THORNTON O'CONNOR
TOWN PLANNING

Response to ABP Opinion

Milltown Park, Sandford Road, Dublin 6

Submitted on Behalf of
Sandford Living Limited

Figure 2.1: Extract from Map H Demonstrating the Z15 Zoning of the Subject Site (Indicatively Outlined in Red) and the Wider Z15 Lands at the Subject Location

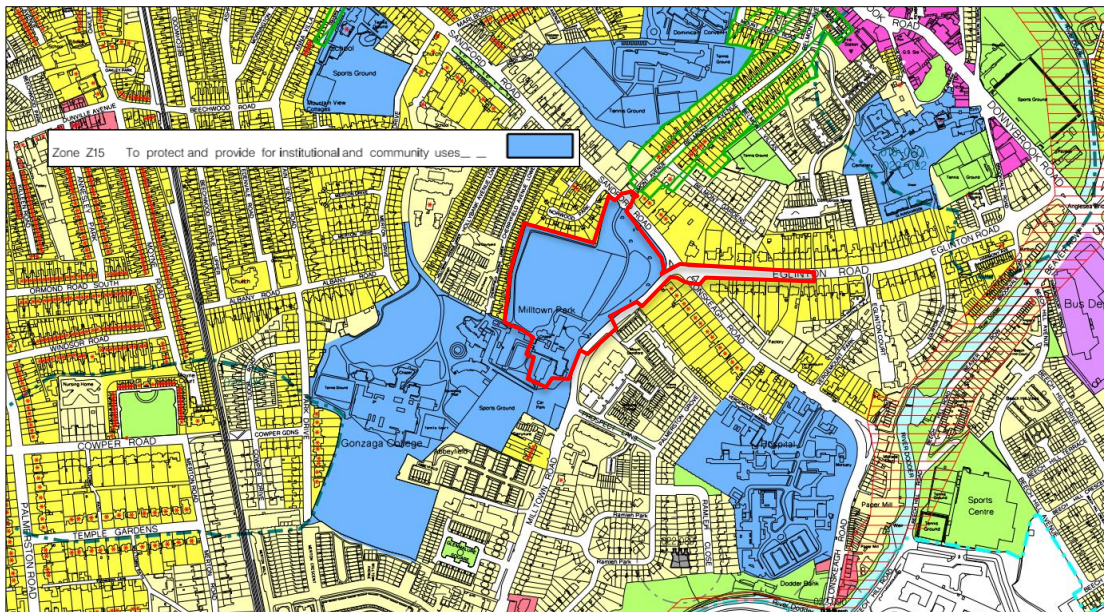
'Further elaboration, including a map to an appropriate scale, of land uses across the entire Z15 land use zoning at Milltown Park.'

In response to this item, we have firstly provided the zoning map in Figure 2.1 to clearly demonstrate the entire Z15 zoning at the subject lands with the subject application site annotated indicatively in red, noting that the road and infrastructure works proposed on Milltown Road, Sandford Road and Eglinton Road are also outlined in red.

Figure 2.4: Extract of Illustrative Landscape Masterplan Submitted as Part of this Planning Application

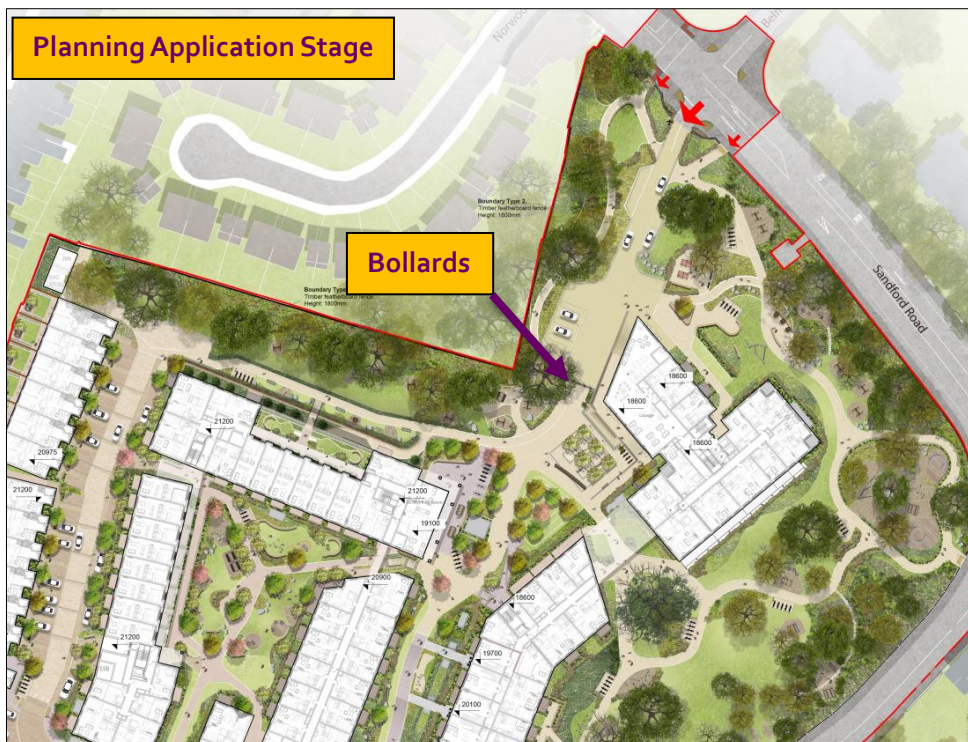
In response to Item No. 2, the layout of the public plaza has been revised and vehicular parking spaces have been completely removed from this area. We note that bollards will prevent vehicles from accessing the plaza area, which will ensure that this plaza space is a safe and enjoyable environment for the public and residents.

It is our professional planning opinion that the revised treatment of the public plaza and the Sandford Road access appropriately responds to Item No.2 of the An Bord Pleanála Opinion. Please see Figures 2.3 and 2.4 below for a comparison between the treatment of the public plaza and the Sandford Road entrance at pre-planning tri-partite stage and the significantly improved revised treatment now submitted.
